Change Order #10

Regional Linear Park Phase II (Hike & Bike Trail)

Project: Regional Linear Park Phase II
Project#: STP 2019 (086) TP
Contract: C-18-199-02-12
CSJ: 0921-02-409
Limits: Hall Acres to Ridge Road

CONSTRUCTION CONTRACT CHANGE ORDER NUMBER: 10

CK DN:	MNR	CONT	SECT	JOB	HIGHWAY
CK DW:	RLM	0921	02	409	RLPP
CK TR:	HCS	DIST	COUNTY	SHEET NO.	
		PHR	HIDALGO	139

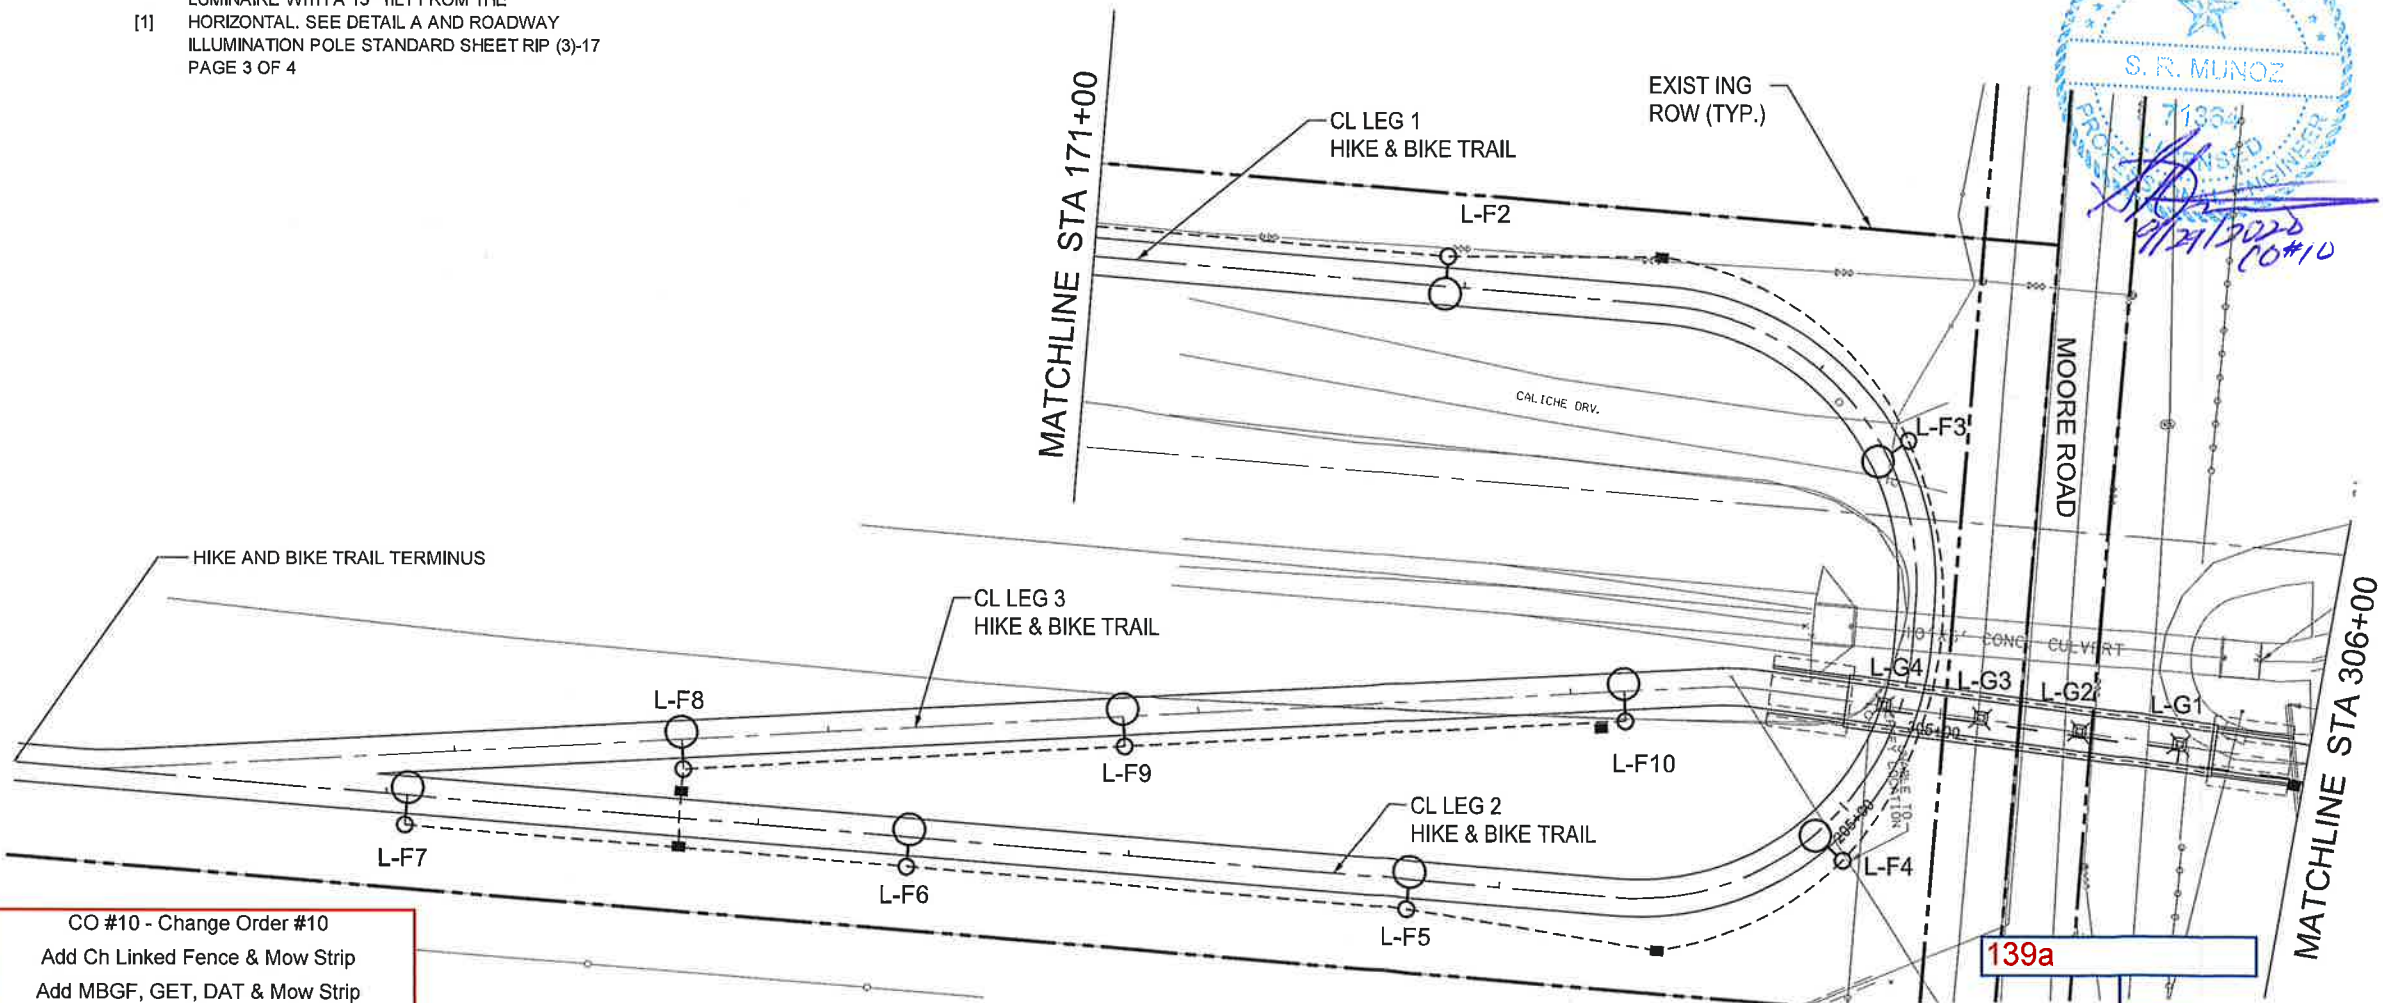
ILLUMINATION QUANTITIES - SHEET TOTALS					
ITEM	DESCR CODE	DESCRIPTION	UNIT	QUANTITIES	
					SHEET 19
416	6029	DRILL SHAFT (RDWY ILL POLE) (30 IN)	LF	88	CO #10
HC 001		FURNISH AND INSTALL LIGHTING FIXTURE (LED WATERPROOF) TYPE IXL3525-055UV-F5M-SSND-SSL (IP68) WITH AN IP68 GLAND, IP68 JUNCTION BOX AND STEEL WIRE MESH COVER ASSEMBLY PROTECTION	EA	4	
610	6500	IN RD ILL (TY SA) 30S-4 (400W EQ) LED WITH TRASTAR DURALIGHT DURA-ST40-4K-120-2-GR-SCLB (1)	EA	7	
610	6500	IN RD ILL (TY SA) 30S-4 (400W EQ) LED WITH TRASTAR DURALIGHT DURA-ST40-4K-120-2-GR-SCLB		4	
618	6023	CONDT (PVC) (SCH 40) (2")	LF	1475	CO #10
620	6007	ELEC CONDR (NO.8) BARE	LF	1725	CO #10
621	6007	TRAY CABLE (4 CONDR) (8 AWG)	LF	1,490	
684	6009	TRF SIG CBL (TY A) (12 AWG) (4 CONDR)	LF	180	
HC 002		ELEC CONDR (NO.10) PVC JACKET, 90 DEGREE CELCIUS INSULATION, 600V	LF	610	CO #10
HC 009		GALVANIZED RIGID STEEL CONDUIT (1-1/4")	LF	150	
624	6001	GROUND BOX TY A (122311)	EA	7

144a

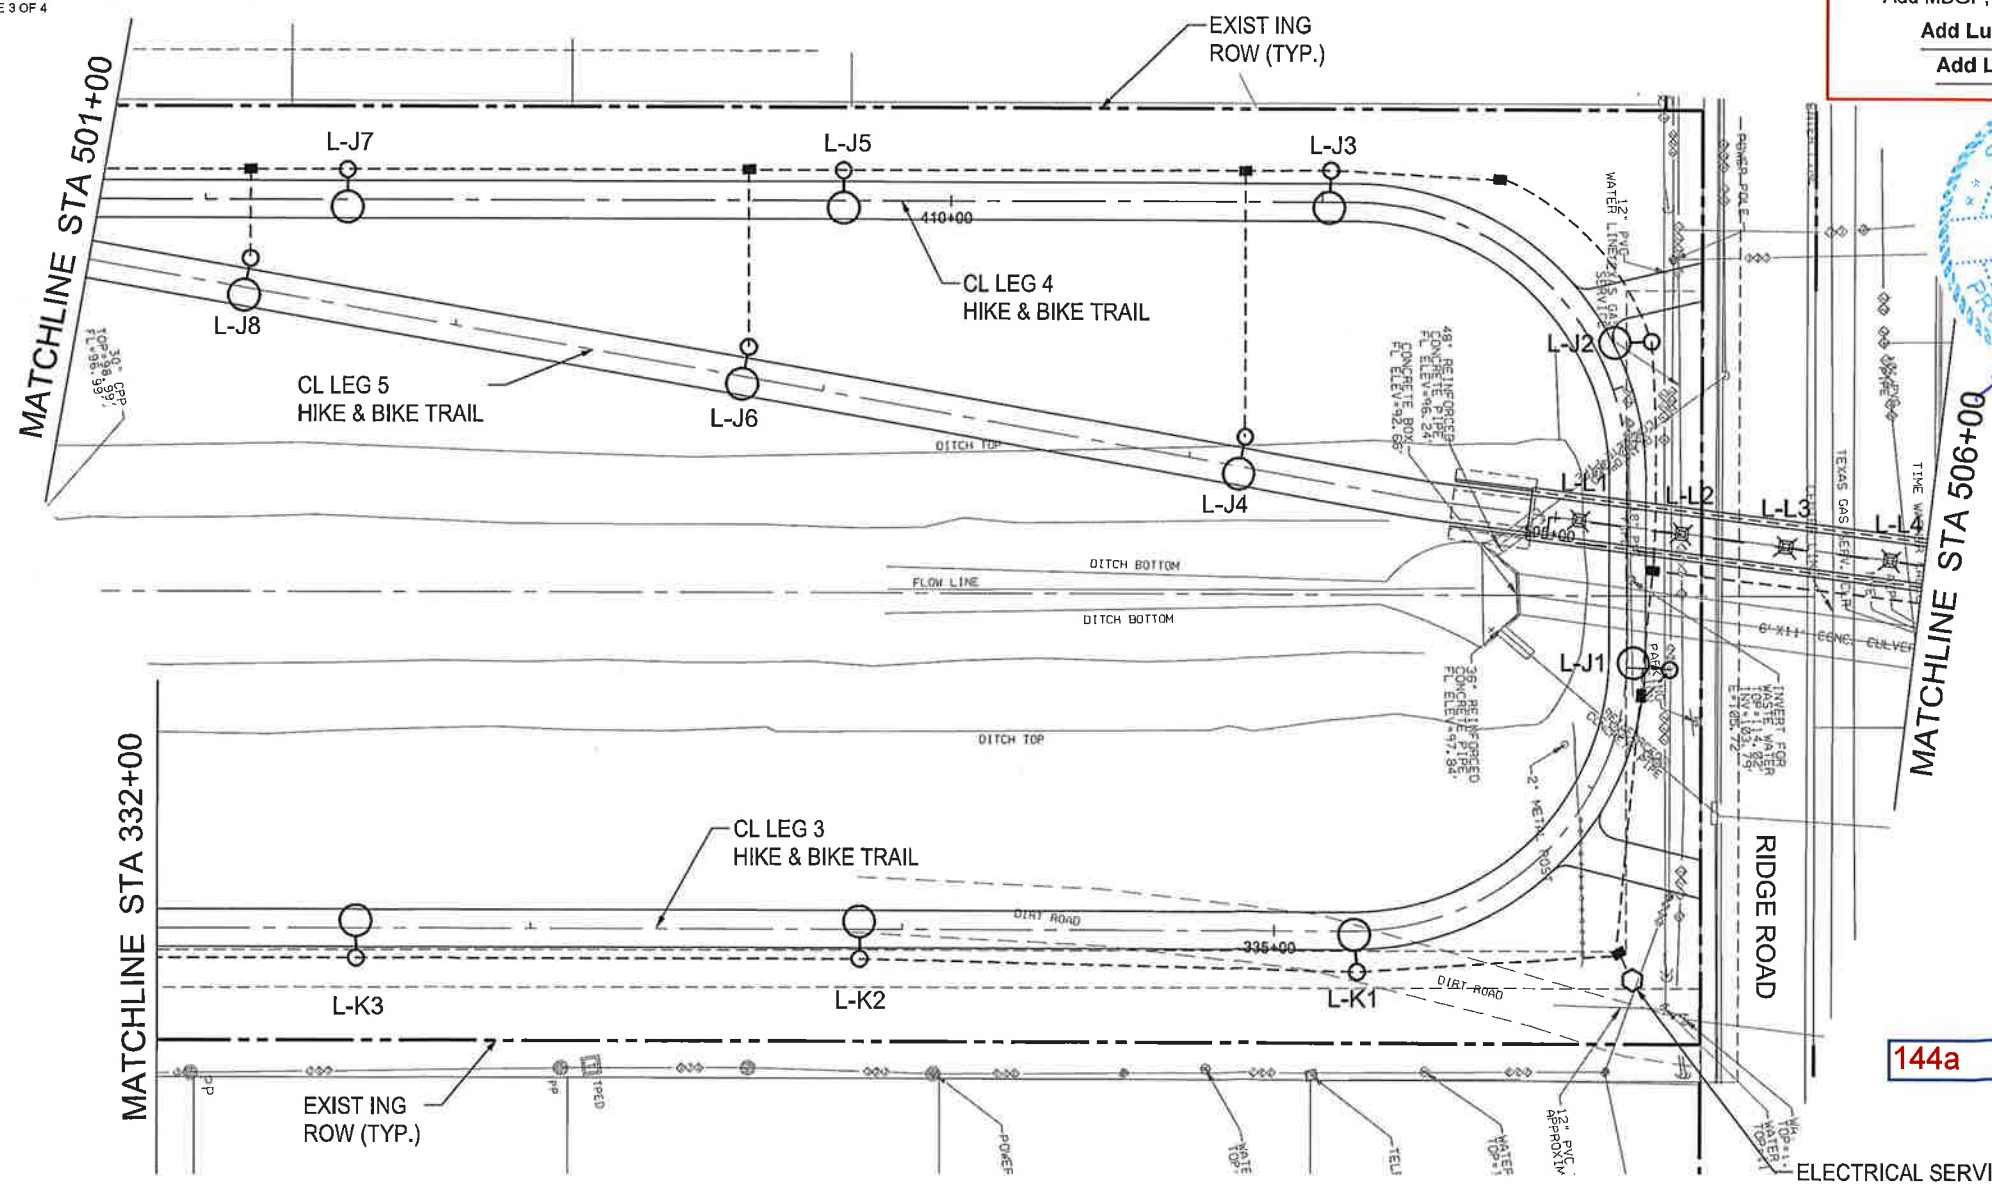
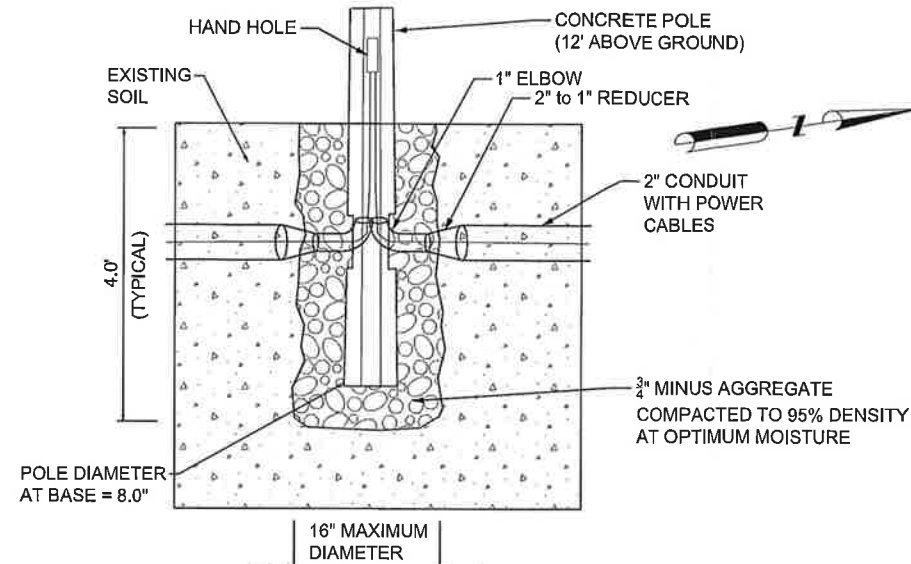
ILLUMINATION QUANTITIES - SHEET TOTALS					
ITEM	DESCR CODE	DESCRIPTION	UNIT	QUANTITIES	
					SHEET 20
HC 011		FURNISH AND INSTALL VISIONAIRE LIGHTING PREMIER II (PRE-2-T4-48LC-3-4K-UNV-PT-FINISH) EQ LUMINAIRE FIXTURE AND LUMINAIRE POLE TRADITIONAL CONCRETE INC. D412-SG-EA-3T COMPLETE IN PLACE, INCLUDING ALL COMPONENTS AND FOUNDATION.	EA	11	
HC 001		FURNISH AND INSTALL LIGHTING FIXTURE (LED WATERPROOF) TYPE ILX3525-055UV-F5M-55ND-SSL (IP68) WITH AN IP68 GLAND, IP68 JUNCTION BOX AND STEEL WIRE MESH COVER ASSEMBLY PROTECTION	EA	2	
618	6023	COND (PVC) (SCH 40) (2")	LF	610	
620	6007	ELEC CONDR (NO.8) BARE	LF	610	
684	6009	TRF SIG CBL (TY A) (12 AWG) (4 CONDR)	LF	805	
HC 002		ELEC CONDR (NO.10) PVC JACKET, 90 DEGREE CELCIUS INSULATION, 600V	LF	0	CO #10
HC 009		GALVANIZED RIGID STEEL CONDUIT (1-1/4")	LF	50	
624	6001	GROUND BOX TY A (122311)	EA	4

145a
 CO #10 - Change Order #10
 Add Ch Linked Fence & Mow Strip
 Add MBGF, GET, DAT & Mow Strip
 Add Luminaire Drill Shaft
 Add Luminaire Wiring

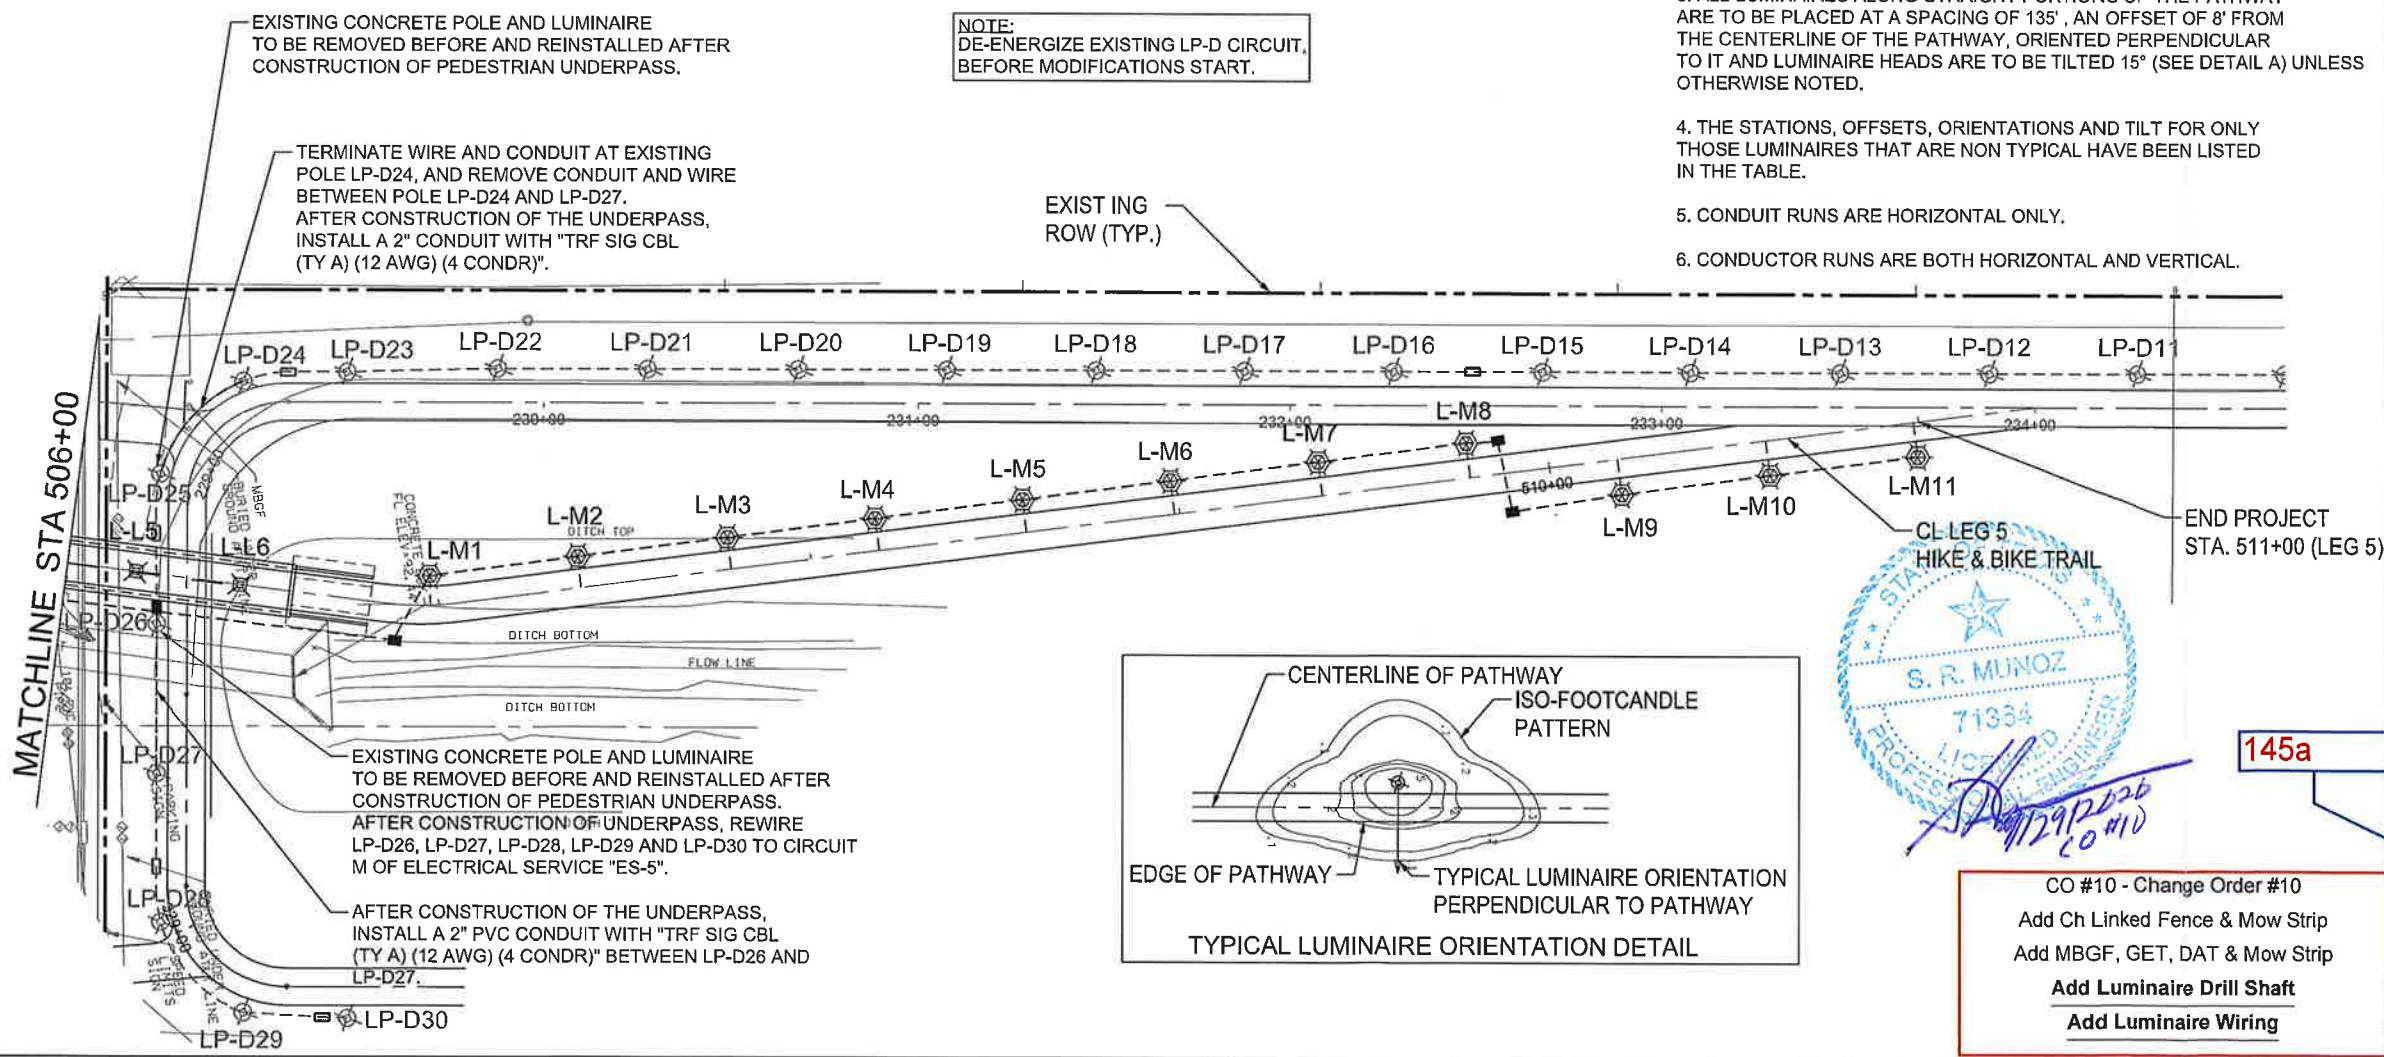
NOTE: DE-ENERGIZE EXISTING LP-D CIRCUIT, BEFORE MODIFICATIONS START.

EXISTING CONCRETE POLE AND LUMINAIRE TO BE REMOVED BEFORE AND REINSTALLED AFTER CONSTRUCTION OF PEDESTRIAN UNDERPASS.

TERMINATE WIRE AND CONDUIT AT EXISTING POLE LP-D24, AND REMOVE CONDUIT AND WIRE BETWEEN POLE LP-D24 AND LP-D27. AFTER CONSTRUCTION OF THE UNDERPASS, INSTALL A 2" CONDUIT WITH "TRF SIG CBL (TY A) (12 AWG) (4 CONDR)".

EXISTING CONCRETE POLE AND LUMINAIRE TO BE REMOVED BEFORE AND REINSTALLED AFTER CONSTRUCTION OF PEDESTRIAN UNDERPASS. AFTER CONSTRUCTION OF UNDERPASS, REWIRE LP-D26, LP-D27, LP-D28, LP-D29 AND LP-D30 TO CIRCUIT M OF ELECTRICAL SERVICE "ES-5".

AFTER CONSTRUCTION OF THE UNDERPASS, INSTALL A 2" PVC CONDUIT WITH "TRF SIG CBL (TY A) (12 AWG) (4 CONDR)" BETWEEN LP-D26 AND LP-D27.
